Sheet: /
File: Philco 46-480 Schematic.kicad_sch

Title: PHILCO 46-480 SCHEMATIC

Size: E	Date: 2020-04-05	Rev: 1
KiCad E.D.A. 9.0.5		Id: 1/1

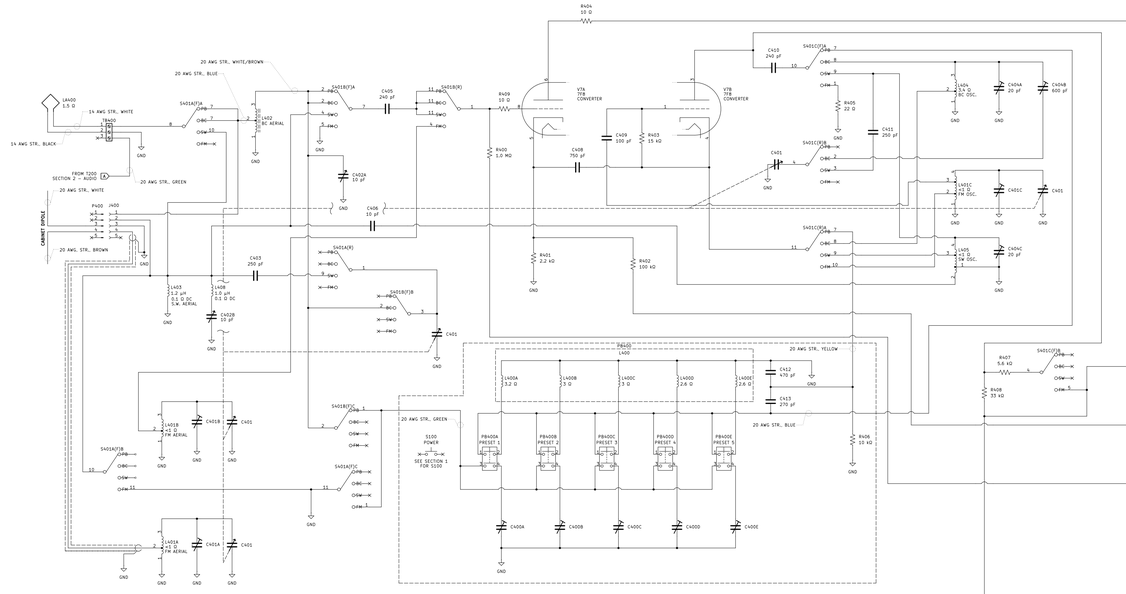
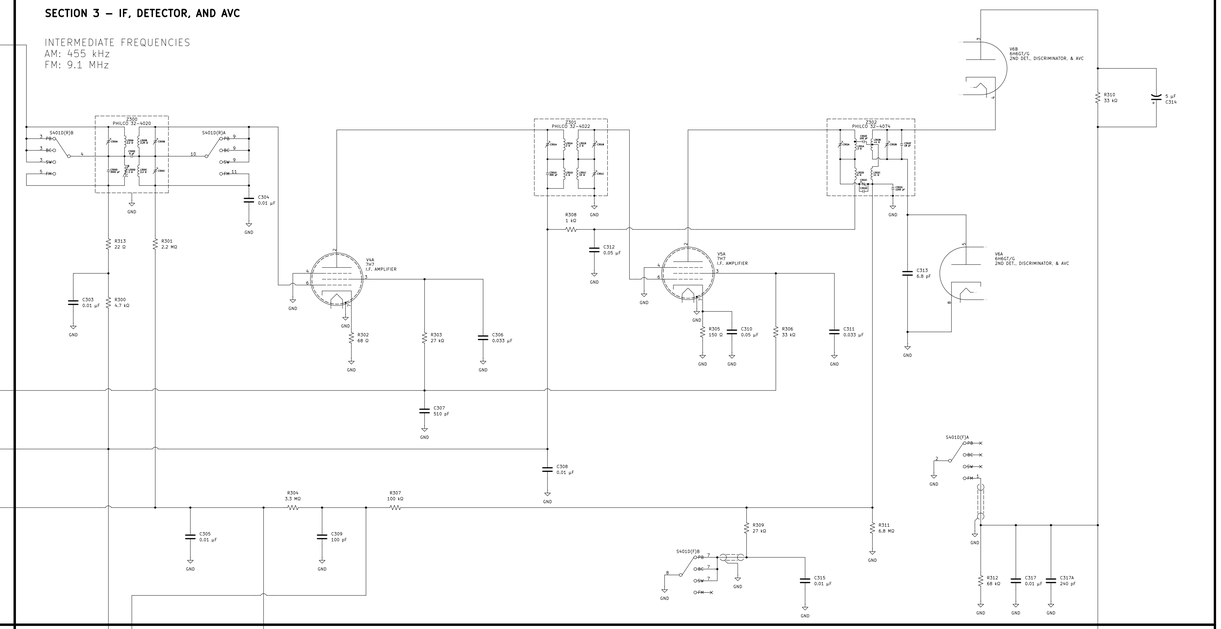
REV 1 CHANGES
* W100 REPLACED BY POLARIZED PLUG.
* F100 MOVED FROM NEUTRAL TO LINE SIDE OF 117 VAC CIRCUIT.
* S100 MOVED FROM NEUTRAL TO LINE SIDE OF PRIMARY 117 VAC CIRCUIT.
* C316A RENAMED TO C317A. IT IS IN PARALLEL TO C317, AND C316 WAS REMOVED DURING PRODUCTION RUN 9.
* C100A & C100B MOVED DOWNSTREAM OF S100, SO AS TO BE DE-ENERGIZED WHEN RADIO POWERED OFF.
* C100A & C100B UPGRADED TO X1Y1 RATED SAFETY CAPACITORS.
* C101 CHANGED FROM 25 µF TO 22 µF.
* C102 CHANGED FROM 0.5 µF TO 0.47 µF.
* C200, C201, C202, C203 CHANGED FROM 0.01 µF TO 0.0068 µF.
* C201, C204, C205, C206 CHANGED FROM 0.006 µF TO 0.0068 µF.
* C306, C311 CHANGED FROM 0.03 µF TO 0.033 µF.
* C309 CHANGED FROM 68 pF TO 100 pF.
* C405 CAN1 CHANGED FROM 255 pF TO 250 pF.
* C412 CHANGED FROM 485 pF TO 470 pF.
* C413 CHANGED FROM 265 pF TO 270 pF.
